Title		19-POWER SOLUTION	
Size	Document Number	Advanced DMA (D117)	
C		Sheet	19 of 21
Date:	Friday, November 04, 2005	Rev	ROF

20-Design Notes

Advanced DMA (D117)

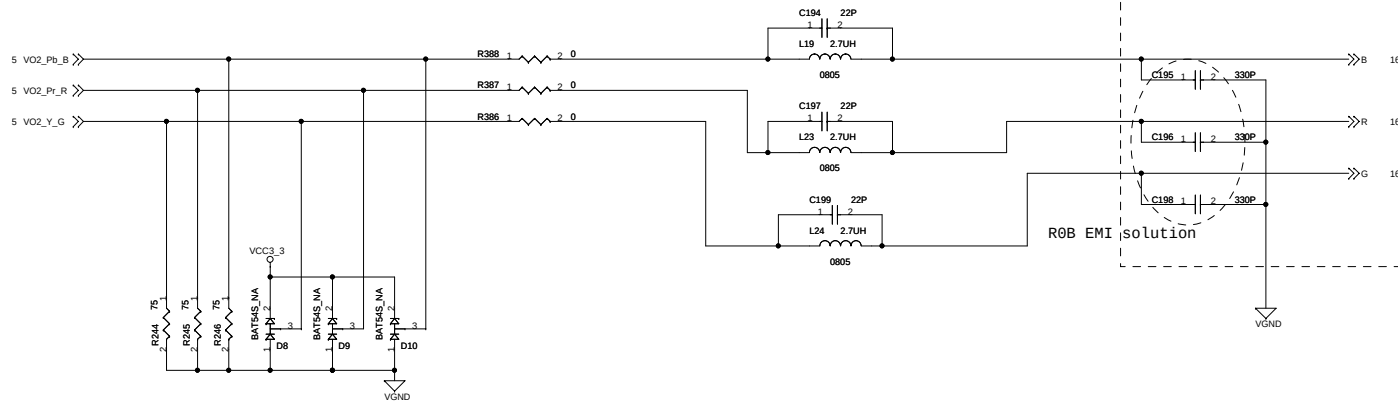
Remove D1/D2/D3/D4
I/F and change to
RGB for DVI-I

Add composite CVBS

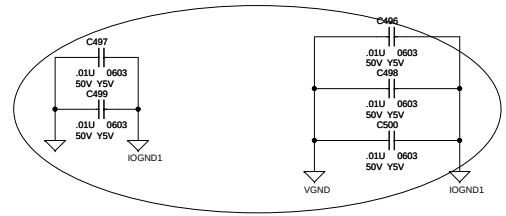
EMI issue

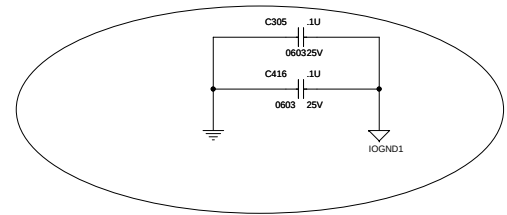
EMI issue

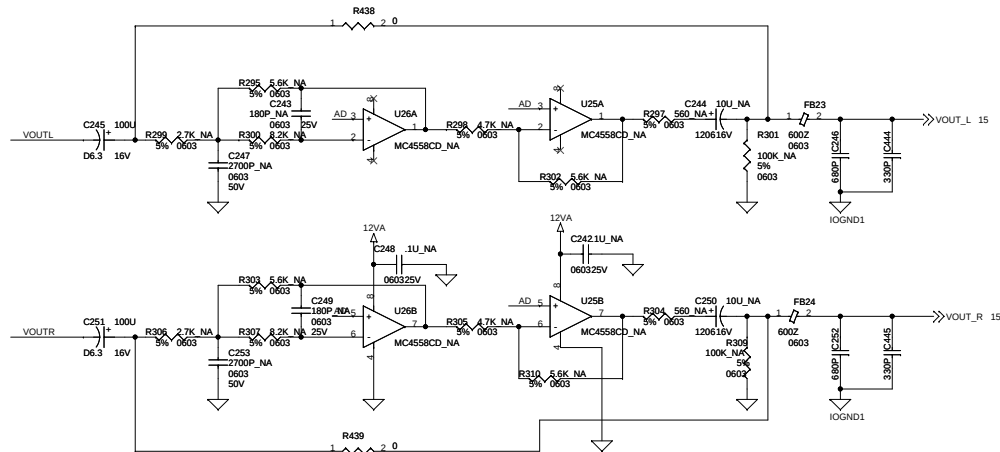
19/21
add BEAD L43 for VCC12V transfer to 12VA

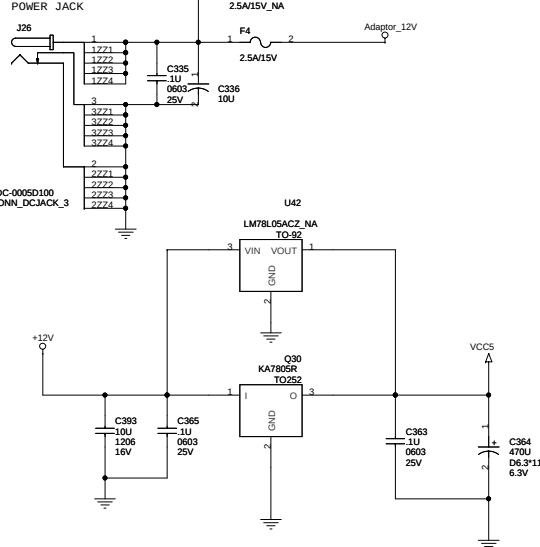
Add in 10/30 for EM8622

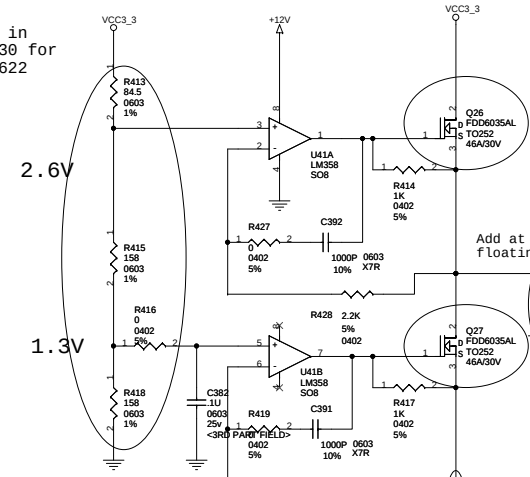
Add at 11/1 for load floating issue

Add at 11/1 for load floating issue

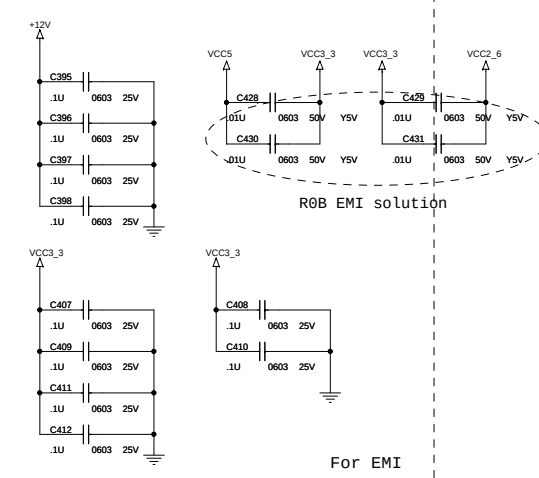
10/21
Add for regulated 3.3V power supply

For EMI

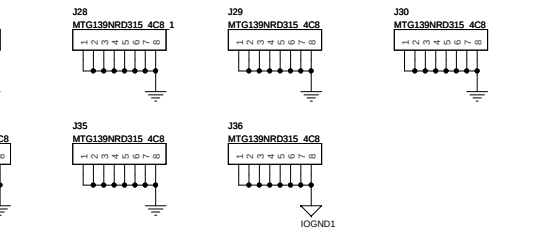
R0B EMI solution

For EMI
